**Appl. No.** : **09/988,728**  
**Filed** : **November 16, 2001**

### **REMARKS**

**AMENDMENTS TO THE DRAWINGS**

FIG. 1B

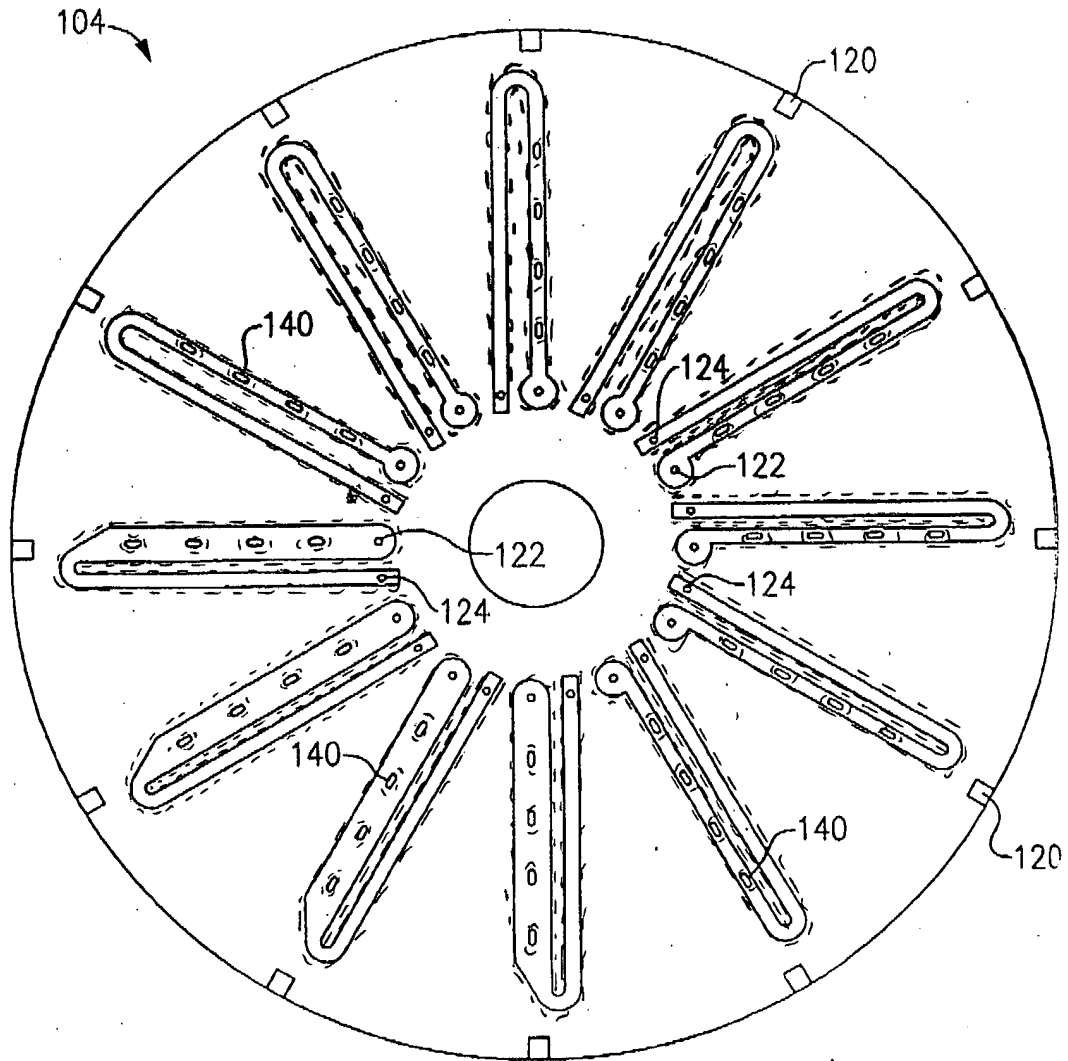
With respect to Figure 1B, the Examiner stated that reference sign 140 indicates “target zones” on substrate 106, which is not shown in the figure. Applicant notes that the target zones 140 are clearly shown on substrate 106 in Figure 1C. Applicant has corrected Figure 1B to dash out portions that would not be visible from a top-down view. With respect to Figure 1C, the Examiner indicated that chambers 164 should not be visible. Applicant has corrected Figure 1C to show these features in broken lines.

FIG. 1C

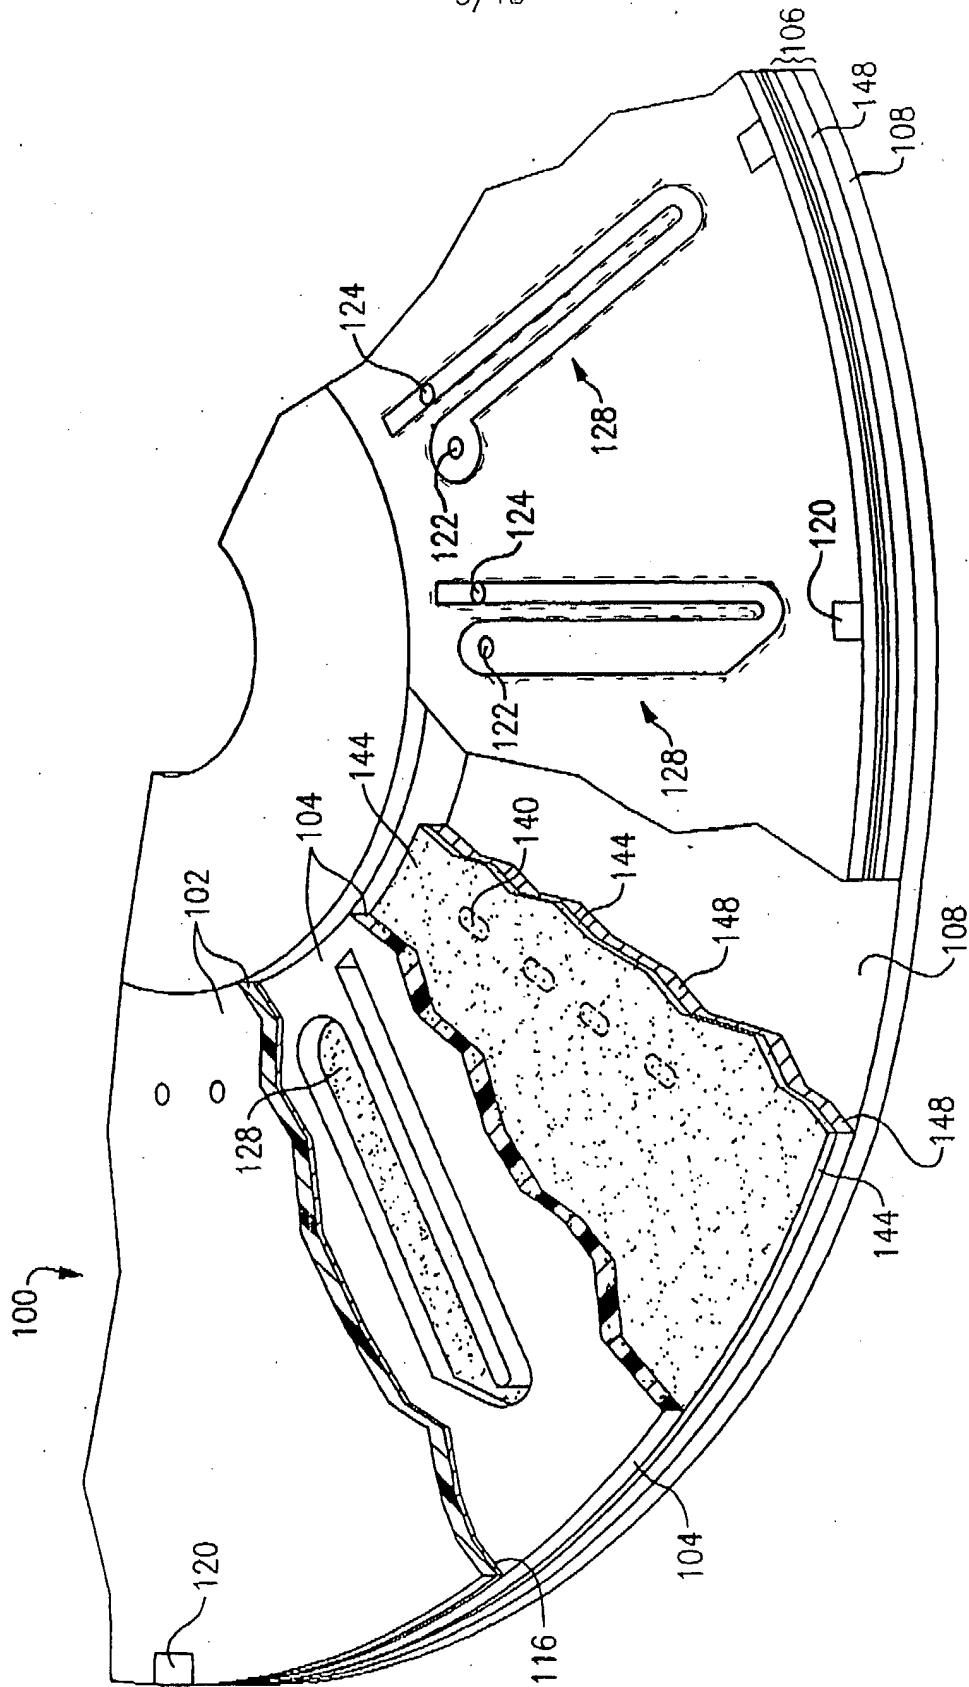
With respect to Figure 1C, the Examiner stated that the chambers 128 should not be visible on the right hand portion of the Figure. Applicant has amended the figure to correct this.

FIG. 2A

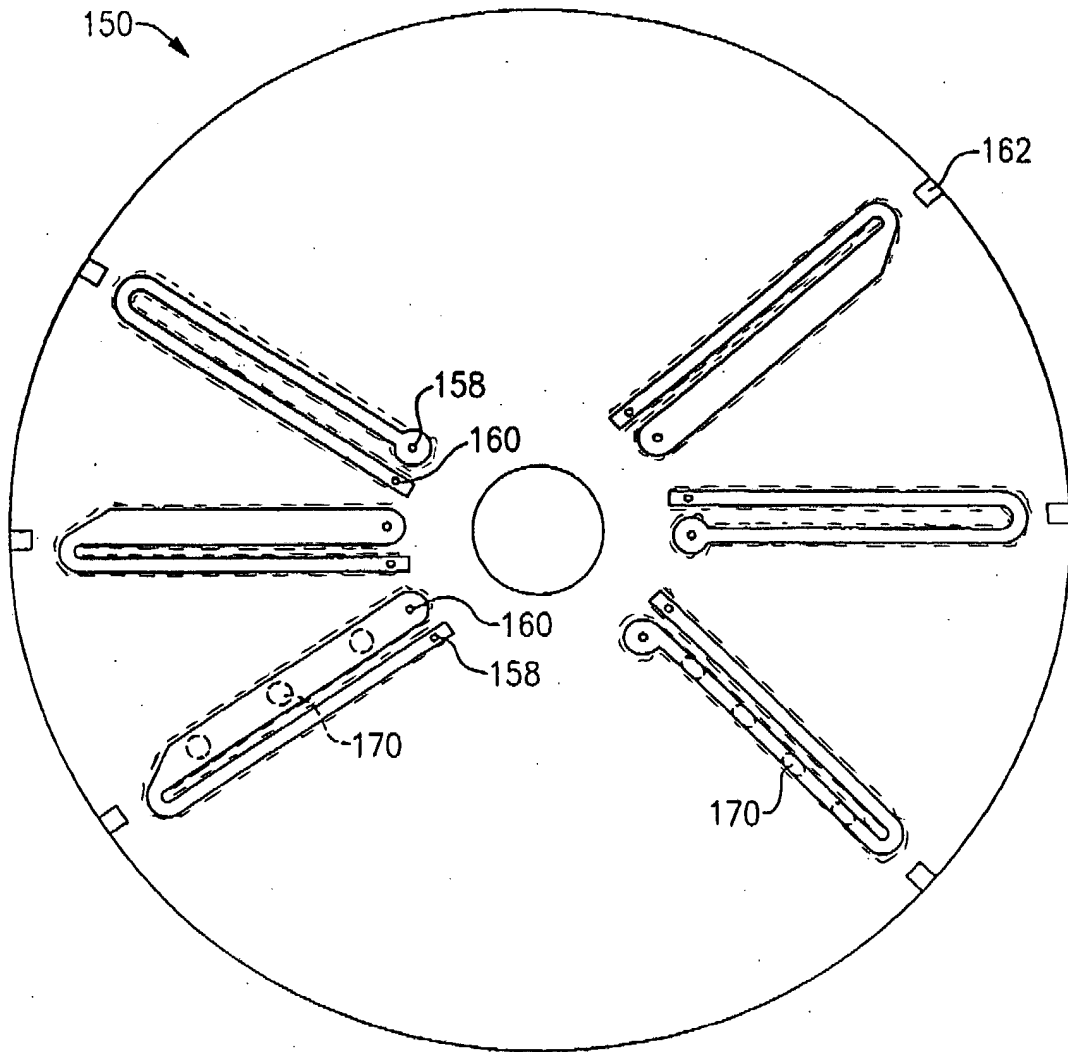
With respect to Figure 2A, the Examiner indicated that the positioning of reference sign 150 is misleading. Applicant has corrected this by the present amendments.

FIG. 2C

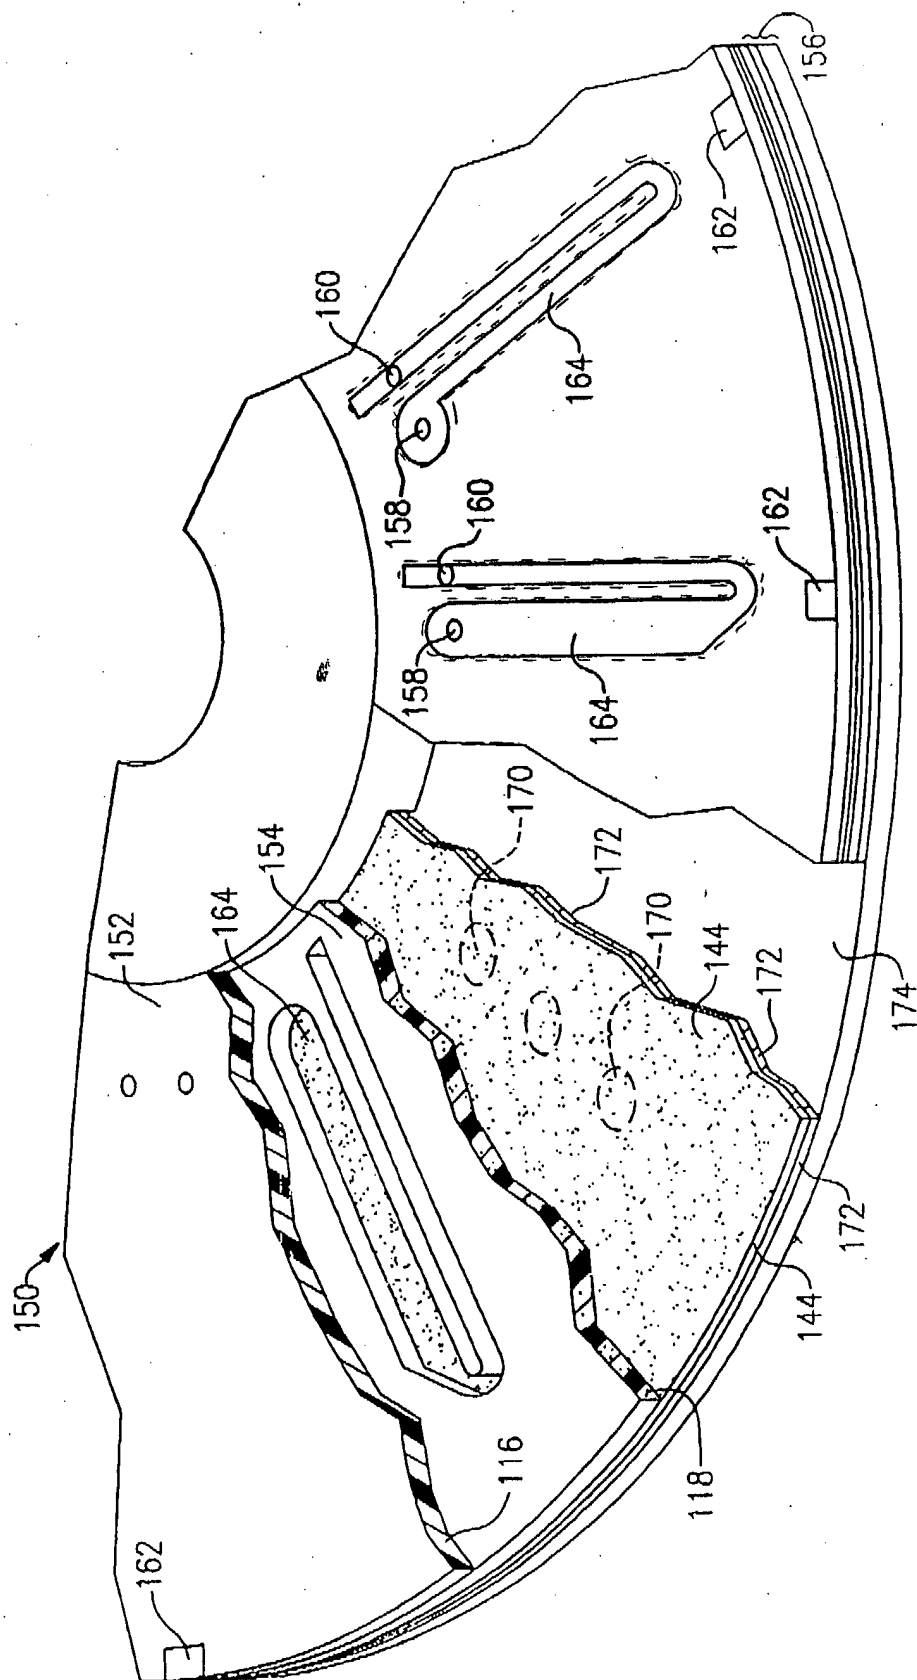
With respect to Figure 2C, the Examiner stated that the chambers 164 should not be visible on the right hand portion of the Figure. Applicant has amended the figure to correct this.
